# ADAPTABLE HOUSING & LHDG INDICATIVE COMPLIANCE REPORT FOR DA LODGEMENT

# Lot 1, 1 Veno Street, Heathcote NSW 2233

Prepared for: DK Heathcote Pty Ltd

Status: Report Issue v1.0

#### Unit AG04:

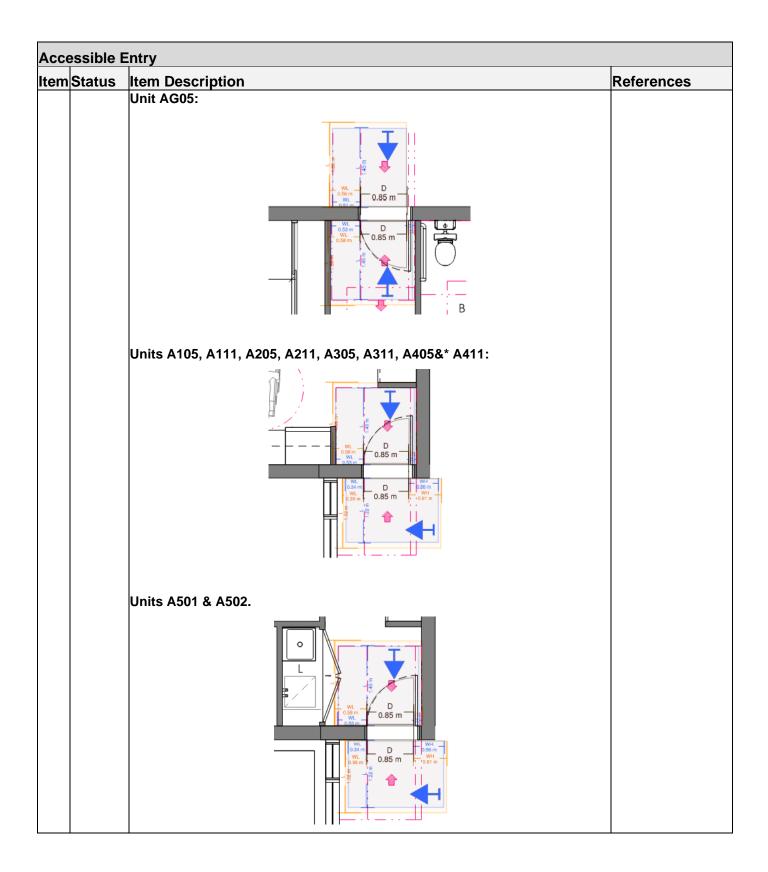
The subject SOU entry doorways appear to comply with AS1428.1-2009 (blue) and AS1428.2-1992 (orange) at post adaptation, as illustrated below:

Acce	essible E	Entry	
tem	Status	Item Description	References
22	CRA	Accessible Entry to be level (i.e 1:40 slope)  Where the accessible entry door is exposed to the weather, it shall be provided with a landing outside the door with a maximum fall of 1:40 and a low threshold at the entry door to exclude water. The threshold shall allow for the smooth transition of a wheelchair (see Figure 4.1). The landing shall be of sufficient area to enable wheelchair manoeuvrability.	Clause 4.3.2 - Landing
		Patio or entry porch  1.40 max. fall  Turf level flush with slab  Minimum overhang  FIGURE 4.1 ENTRY LANDING	
		RLs on plans indicate level accessible entry SOU doorways.	
23	CRA	Threshold to be low level	Clause 4.3.2 - Landing
		Where the accessible entry door is exposed to the weather, it shall be provided with a landing outside the door with a maximum fall of 1:40 and a low threshold at the entry door to exclude water. The threshold shall allow for the smooth transition of a wheelchair (see Figure 4.1). The landing shall be of sufficient area to enable wheelchair manoeuvrability.

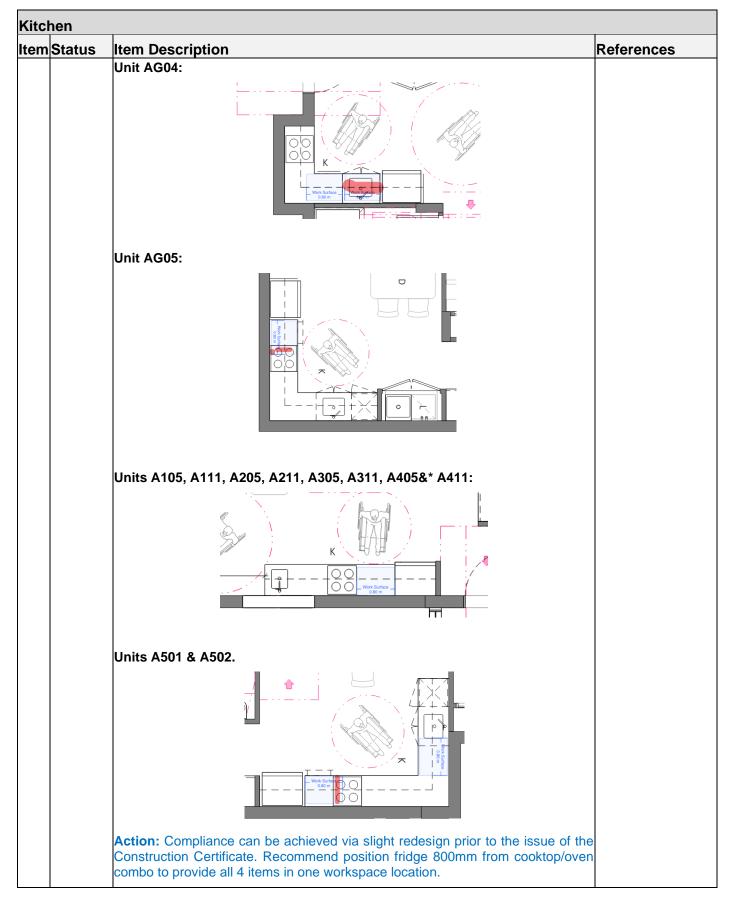
Kitc	Kitchen					
Item	Status	Item Description	References			
43	CRA	Provision for circulation at doors to comply with AS 1428.1  The potential configuration of the kitchen area after adaptation shall be demonstrated prior to certification. The final configuration of the kitchen after adaptation shall be shown to comply with Clause 4.5.3.  No kitchen doors are provided, therefore provisions for door circulation space and dead-end circulation spaces comply with AS 1428.1 within the kitchen area.				
44	CRA	Provision for benches planned to include at least one work surface of 800mm length, adjustable in height from 750mm to 850mm or replaceable (Figure 4.8 from AS 4299-1995)  At least one section of the work surface. Not less than 800 mm in length, should comply with the following:  (a) The work surface should be adjustable or replaceable as a unit at variable heights within the range 750 mm to 850 mm above the finished floor surface. (See Figure 4.8(b).)  (b) Base cabinets, if provided, should be removable over the full 800 mm length of the work surface. The finished floor space of 1500 mm '820 mm should allow a forward approach to the work surface. No more than 500 mm of this clear floor space should extend beneath the work surface. (See Figure 4.8(c).)  As illustrated below, the subject units require provision for not less than one worksurface:

Kitcl	hen		
Item	Status	Item Description	References
45	CRA	Refrigerator adjacent to work surface	Clause 4.5.5 - Work Surfaces
		The subject units require provision for a designated 800mm work surface adjacent the refrigerator; as indicated in Item 44. Refer to Item 44 for further details.  Action: Compliance can be achieved via slight redesign prior to the issue of the Construction Certificate.	
46	CRA	Kitchen sink adjustable heights from 750 to 850mm or replaceable  The sink and an adjacent work surface which shall be a minimum of 800 mm in length, and may be the work surface referred to under Clause 4.5.5, shall comply with (a) to (f)	Clause 4.5.6 - Sinks
47	CRA	Note to be added prior to issue of the Construction Certificate  Kitchen sink bowl max. 150mm deep	Clause 4 F.G. Sinks
47	CRA	The sink and an adjacent work surface which shall be a minimum of 800 mm in length, and may be the work surface referred to under Clause 4.5.5, shall comply with (a) to (f)	Clause 4.5.6 - Sinks

Note on plans indicate compliance.	
53	CRA	Worksurface min. 800mm length adjacent to cooktop at same height  Circulation spaces and clearances shall be as for sinks (see Clause 4.5.6). Cooktops shall have controls which do not require reaching over the hotplates to adjust them. Controls shall have raised cross-bars for ease of grip. Cooktops shall have an adjacent work surface of 800 mm minimum length at the same height. Cooktops should be provided with isolating switches or gas stop valves which can be easily and safely operated while the cooktop is in use.	
		Cooktop required to be adjacent an 800mm workspace as illustrated in Item 44. Refer to Item 44 for further details.	
		<b>Action:</b> Compliance can be achieved via slight redesign prior to the issue of the Construction Certificate.	
54	CRA	Oven located adjacent to an adjustable height or replaceable work surface  Ovens shall be located adjacent to a work surface in accordance with Clause 4.5.5 (see Figure 4.10). Where the oven door is hinged, the clear work surface shall be on the opposite side to the hinge  Oven required to be adjacent to an 800mm workspace as illustrated in Item 44.

Refer to Item 44 for further details.  Action: Compliance can be achieved via slight redesign prior to the issue of the Construction Certificate.

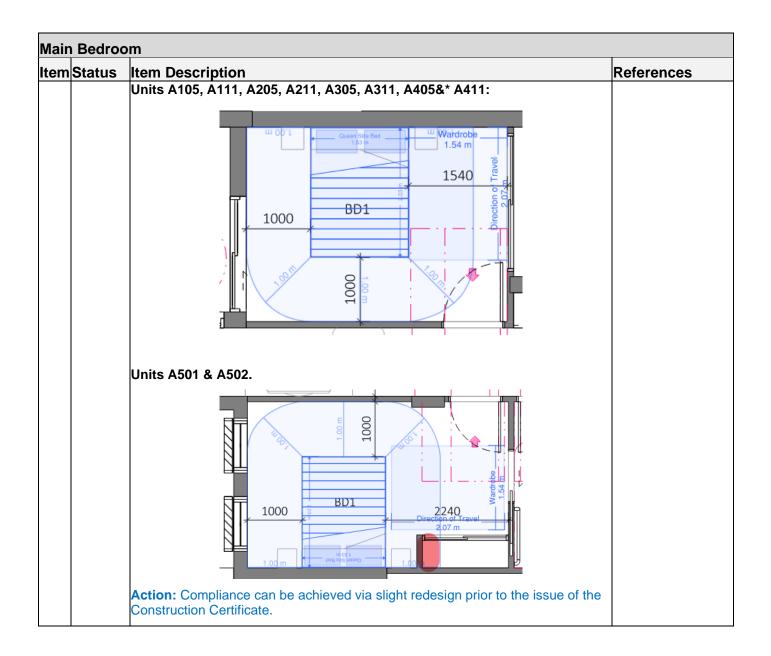
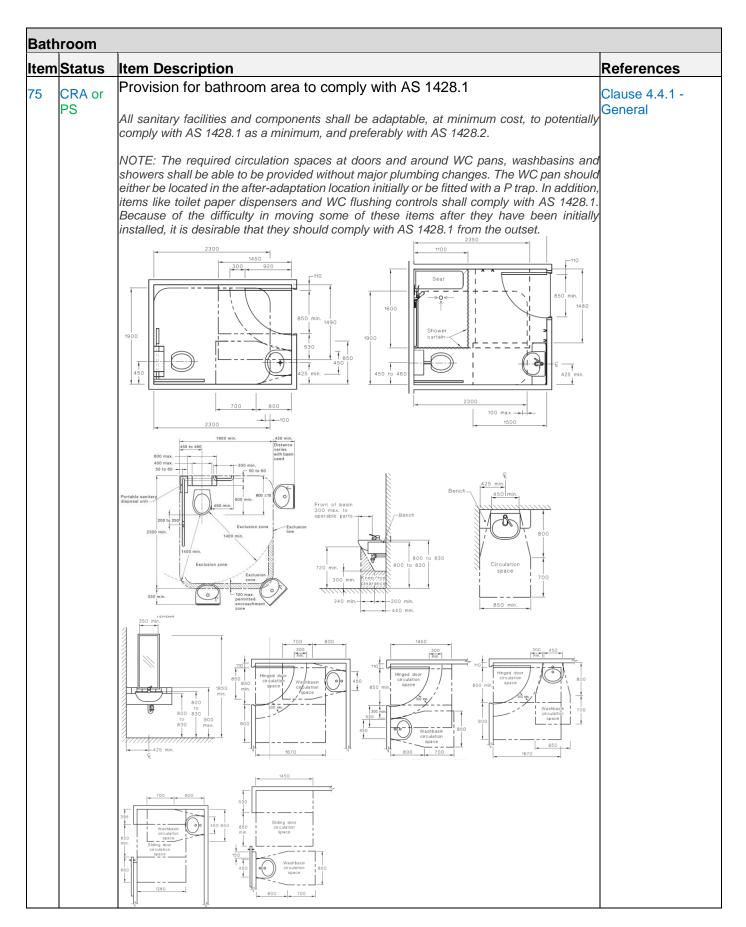
om Item Description	References
At least one bedroom of area sufficient to accommodate queen size bed and wardrobe and circulation space requirements of AS 1428.2  At least one bedroom shall be capable of accommodating a queen size bed and a wardrobe	Clause 4.6.1 - Bedroom Areas
Provision of a queen size bed, not less than 1000mm circulation space on both sides and foot of bed, and provision of a wardrobe and space for a 180° turn in front of the wardrobe circulation spaces are provided for the subject units at post-adaptation, with the exception of Units A501 & A502, as illustrated below:	1
Unit AG04:  Wardrobe  1.54 m  2040  2040  1.00 m  1.00 m	
Unit AG05:  1000 BD1 1540 BD1 1540 BD1	
	At least one bedroom of area sufficient to accommodate queen size bed and wardrobe and circulation space requirements of AS 1428.2  At least one bedroom shall be capable of accommodating a queen size bed and a wardrobe and the circulation space requirements of AS 1428.2 clear of wardrobe fixtures.  Provision of a queen size bed, not less than 1000mm circulation space on both sides and foot of bed, and provision of a wardrobe and space for a 180° turn in front of the wardrobe circulation spaces are provided for the subject units at post-adaptation, with the exception of Units A501 & A502, as illustrated below:  Unit AG04:  Unit AG05:

Bath	Sathroom		
ltem	Status	Item Description	References
		Post adaptive fixtures and circulation spaces are required to comply with the dimensions of AS1428.1-2009 or element(s) requiring review (highlighted red) for the designated units:	
		Unit AG04:	
		B Pan	
		Unit AG05:	
		O.85 m O.	
		Units A105, A111, A205, A211, A305, A311, A405&* A411:	
		But the state of t

Bath	Bathroom				
	Status	Item Description	References		
		Action: Compliance can be achieved via slight redesign or in some cases an Access performance solution can be undertaking prior to the issue of the Construction Certificate.			
76	CRA	Slip-resistant floor surface  Floor surfaces shall be slip-resistant to comply with AS/NZS 3661.1.	Clause 4.4.2 - Floor Surface		
		Note on plans indicate slip resistant floor surface shall be provided.			
77	CRA	Shower recess-no hob. Minimum size 1160 x 1100mm to comply with AS 1428.1 (Refer to Figures 4.6 and 4.7 of AS 4299-1995)  **Total Company State of Section 1995  **Total Company State 1995  **Total Com

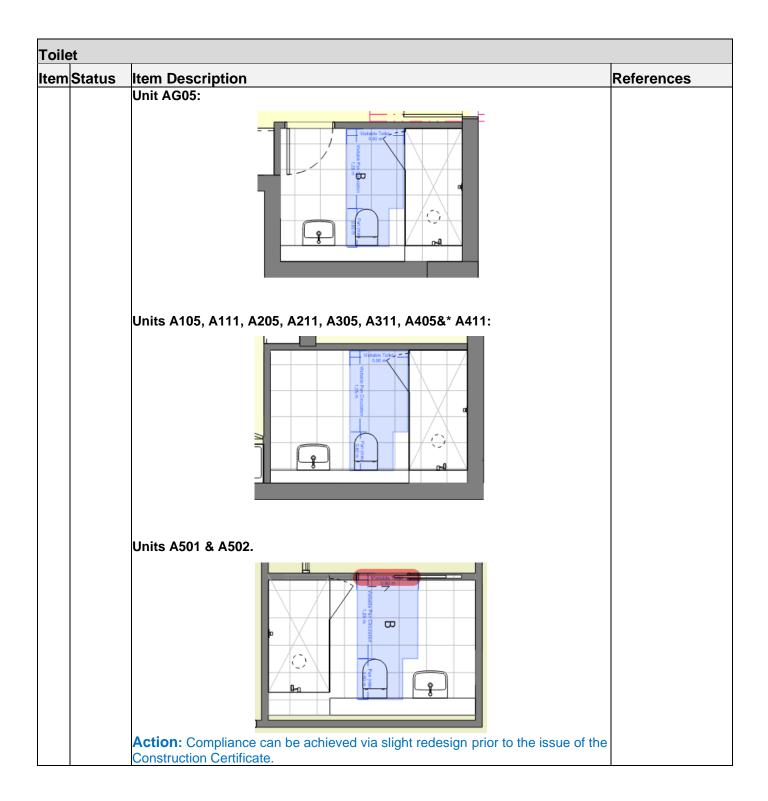
Toile	et		
Item	Status	Item Description	References
ltem 92	CRA	Provision of either 'visitable toilet' or accessible toilet  Each housing unit shall be provided with either a visitable toilet or an accessible toilet. Where a separate toilet and bathroom are used with the intention of future unification, the WC pan shall initially be positioned at the correct distance from any fixed walls. Refer to Figure 4.3.    Vali	Clause 4.4.3 - Toile
		Provision for this item appears to be indicated on the post-adaption plans as illustrated in Item 75.  In addition, provision for a visitable toilet pre-adaptation also appears to be made for the subject units as illustrated below, with the exception of Units A501 & A502:  Unit AG04:

Toile	et		
Item	Status	Item Description	References
93	CRA	Provision to comply with AS 1428.1  All sanitary facilities and components shall be adaptable, at minimum cost, to potentially	Clause 4.4.1 - General
		comply with AS 1428.1 as a minimum, and preferably with AS 1428.2.  NOTE: The required circulation spaces at doors and around WC pans, washbasins and showers shall be able to be provided without major plumbing changes. The WC pan should either be located in the after-adaptation location initially or be fitted with a P trap. In addition, items like toilet paper dispensers and WC flushing controls shall comply with AS 1428.1. Because of the difficulty in moving some of these items after they have been initially installed, it is desirable that they should comply with AS 1428.1 from the outset.	
		Not less than one sanitary compartment is accessible and has provision to comply with AS1428.1-2009 as indicated in Item 75 above.

#### **ELEMENT 6: REINFORCEMENT OF BATHROOM & TOILET WALLS**

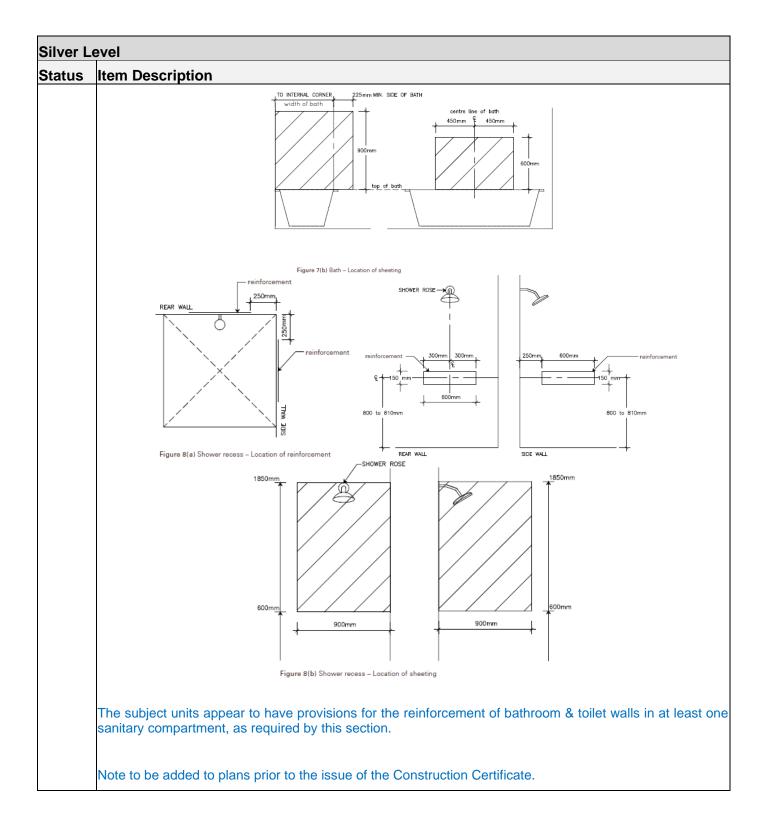
# Silver Level Status **Item Description** Performance Statement: The bathroom and toilet walls are built to enable grabrails to be safely CRA and economically installed. a. Except for walls constructed of solid masonry or concrete, the walls around the shower, bath (if provided) and toilet should be reinforced to provide a fixing surface for the safe installation of grabrails. b. The walls around the toilet are to be reinforced by installing: i. noggings with a thickness of at least 25mm in accordance with Figure 6(a); or ii. sheeting with a thickness of at least 12mm in accordance with Figure 6(b). c. The walls around the bath are to be reinforced by installing: i. noggings with a thickness of at least 25mm in accordance with Figure 7(a); or ii. sheeting with a thickness of at least 12mm in accordance with Figure 7(b). d. The walls around the hobless shower recess are to be reinforced by installing: i. noggings with a thickness of at least 25mm in accordance with Figure 8(a); or ii. sheeting with a thickness of at least 12mm in accordance with Figure 8(b). front of wo structural shee to each wall 600 mm 600 mm 1000mm 600r 300 mm | 150<sup>1</sup>mm 930 to 940mm 1000 mm Figure 6(b) Toilet - Location of sheeting Figure 6(a) Toilet - Location of reinforcement 450mm top of ba Figure 7(a) Bath - Location of reinforcement
